PIC16(L)F1934/1936/1937 Family Silicon Errata and Data Sheet Clarification

The PIC16(L)F1934/1936/1937 family devices that you have received conform functionally to the current Device Data Sheet (DS41364E), except for the anomalies described in this document.

Note: This document summarizes all silicon errata issues from all revisions of silicon, previous as well as current. Only the issues indicated in the last column of [Table 2](#) apply to the current silicon revision (A9).

FIGURE 1: INSTRUCTION CYCLE DELAY CALCULATION EXAMPLE

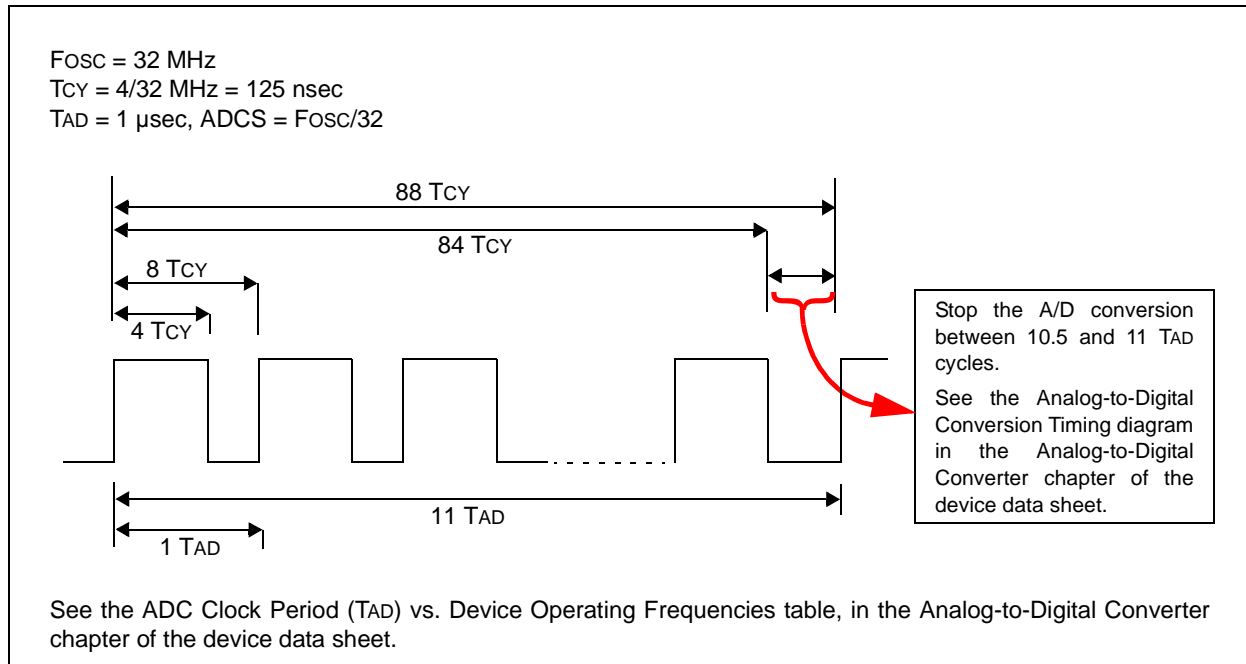
An ADC conversion may not complete under these conditions:

1. When FOSC is greater than 8 MHz and it is the clock source used for the ADC converter.
2. The ADC is operating from its dedicated internal FRC oscillator and the device is not in Sleep mode (any FOSC frequency).

When this occurs, the ADC Interrupt Flag (ADIF) does not get set, the GO/DONE bit does not get cleared, and the conversion result does not get loaded into the ADRESH and ADRESL result registers.

Method 3: This method is provided if the application cannot use Sleep mode and requires continuous operation at frequencies above 8 MHz. This method requires early termination of an ADC conversion. Provide a fixed time delay in software to stop the A-to-D conversion manually, after all 10 bits are converted, but before the conversion would complete automatically. The conversion is stopped by clearing the GO/DONE bit in software. The GO/DONE bit must be cleared during the last 1/2 TAD cycle, before the conversion would have completed automatically. Refer to [Figure 1](#) for details.

In [Figure 1](#), 88 instruction cycles (TcY) will be required to complete the full conversion. Each TAD cycle consists of 8 TcY periods. A fixed delay is

provided to stop the A/D conversion after 86 instruction cycles and terminate the conversion at the correct time as shown in the figure above.
